# ENDL TEXAS

Date: 14 July 2004  
 To: T10 Technical Committee and SNIA OSD TWG  
 From: Ralph O. Weber  
 Subject: Rewrite of OSD Security and Policy/Storage Manager Models

**Figure 1 — Example OSD Configuration**

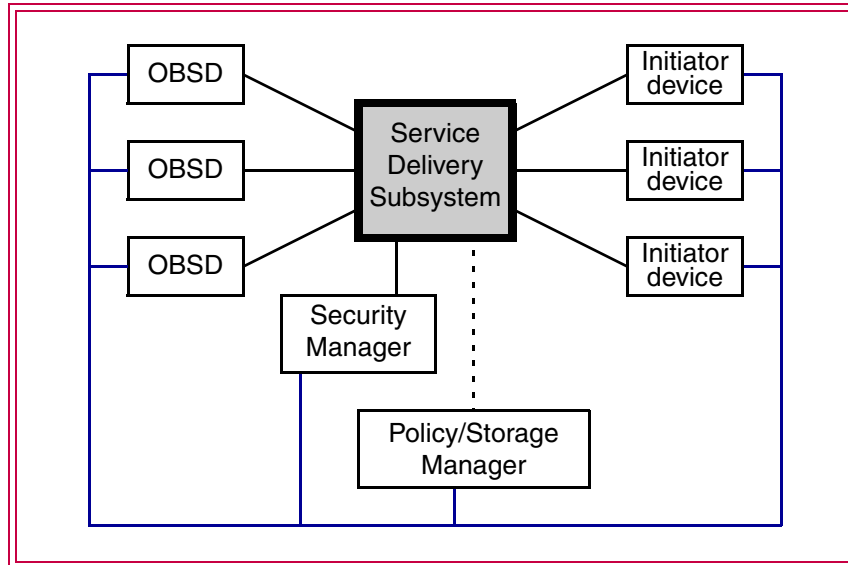
Application clients using multiple SCSI initiator ports share directly access an OBSD (see 3.1.26) via the service delivery subsystem. The service delivery subsystem is used by the components in the OSD model, except possibly the **policy/storage manager and/or security manager**, to intercommunicate. The OSD security model (see 4.9) does not require the service delivery subsystem to provide security-related services (i.e., authentication and **confidentiality**), but is designed to take advantage of whatever security-related services are provided.

The **policy/storage manager** (see 4.x), if present, **coordinates access constraints between OSD device servers and application clients, preparing the capabilities application clients place in CDBs to gain access to OSD objects and command functions.**

The security manager (see 4.9), if present, **secures capabilities in cryptographically protected credentials for OSD device servers and application clients.**

The **policy/storage manager and security manager** may reside in the OBSDs, in applications clients, or as a separate entities.

The **policy/storage manager and security manager** may use the service delivery subsystem and be an application client, but **they** also may use another mechanism to communicate with the OSD device servers and application clients. **Security-related requirements on the communications mechanisms used by the security manager are described in 4.9.2**

**Figure 2 — OSD security model transactions**

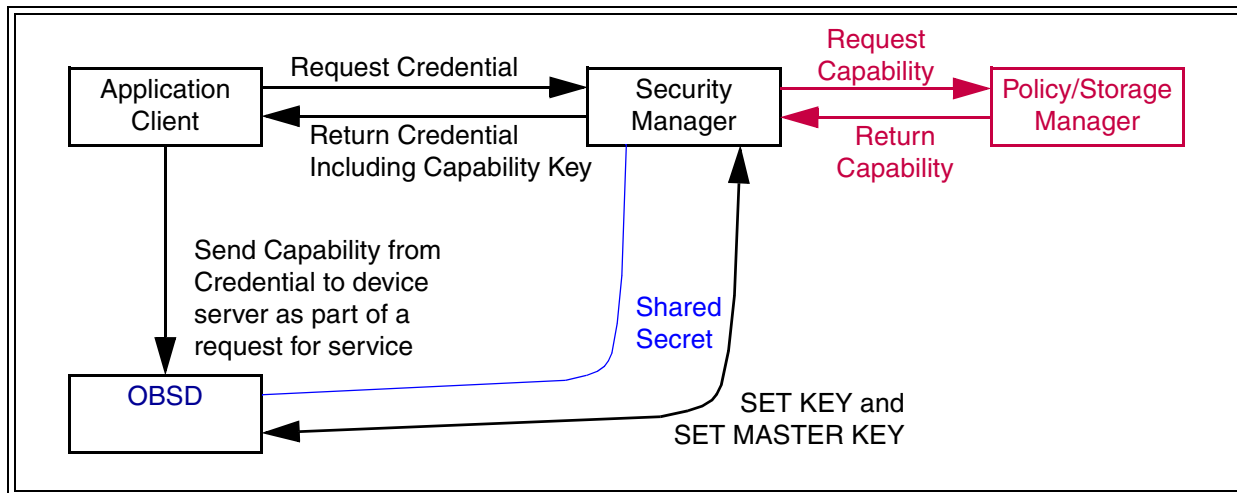
Figure 2 shows the flow of transactions between the components of the OSD security model.

The security manager generates credentials, including capabilities prepared by the policy/storage manager, for authorized application clients at the request of an application client. The security manager returns a capability key with each credential. The credential gives the application client access to specific OSD components. The capability key allows the application client and device server to authenticate the commands and data they exchange with an integrity check value (see 4.9.7).
